Grand County, Utah Request for Proposal (RFP)

1st Amendment – Updated October 1, 2024

Professional Mountain Bike-Optimized Machine-Built Singletrack Trail Construction Services to Construct Phase 1 of the Mud Springs Trail System

REQUEST FOR PROPOSALS (RFP) AMENDMENT 1

Mud Springs Trail System

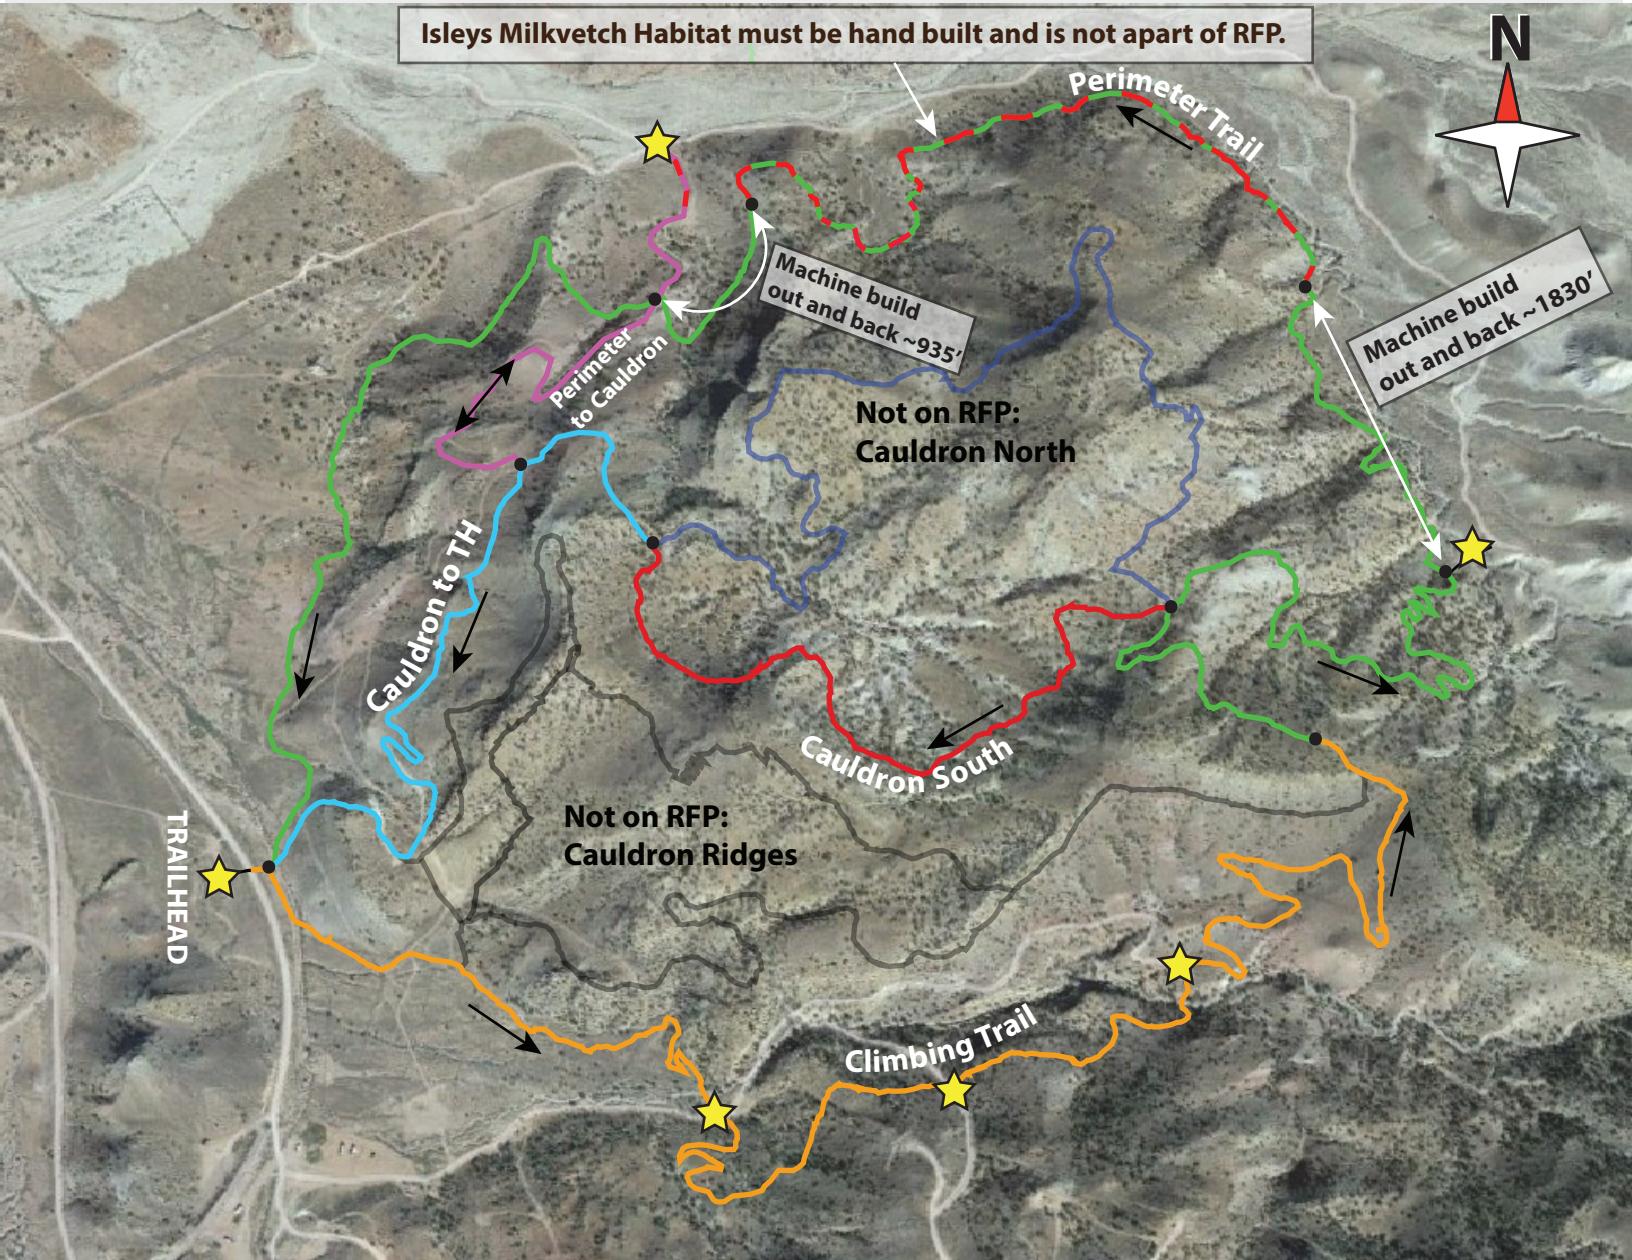
The total amount of machine-built mileage needed for the project has decreased. See updated map and trail information table below.

Group A: 4.30 miles total (Decreased from 5.10 miles)

1. Climbing Trail (1.98 miles, Beginner)
2. Perimeter Trail (2.32 miles, Beginner) (Decreased from 3.12 miles)

Group B: 1.93 miles total (Decreased from 2.01 miles)

3. Cauldron to Trailhead Trail (0.76 miles, Beginner/Intermediate)
4. Cauldron South (0.71 miles, Beginner/Intermediate)
5. Perimeter to Cauldron (0.46 miles of conversion from road to singletrack, Beginner/Intermediate) (Decreased from 0.54 miles)

Trail within Isley's Milkvetch Protected Habitat Zone - Hand Build. Not Apart of RFP.

Clarification: The recommended direction of travel for the Climbing and Perimeter Trails is counter-clockwise. The direction of South Cauldron Trail is east to west. The direction of the Perimeter to Cauldron Trail, which is a road-to-trail conversion, is dual-directional. Directionality has been added to the updated map in section 1 of this document.

1. Climbing Trail (from TH) (1.98 Miles, Machine Build, Beginner) **Group A**
 2. Perimeter Trail (2.32 Miles, Machine Build, Beginner)

3. Cauldron to TH (0.76, Machine Build, Beginner/Intermediate)
 4. Cauldron South (0.71 Miles, Machine Build, Beginner/Intermediate) **Group B**
 5. Perimeter to Cauldron (0.46 Miles, Machine Build, Road-to Singletrack Conversion),

Cauldron North* (1.31 Miles, Hand, Intermediate) *NOT part of this RFP, but will be constructed at the same time by a local crew
 Cauldron Ridges* (Hand, Advanced)
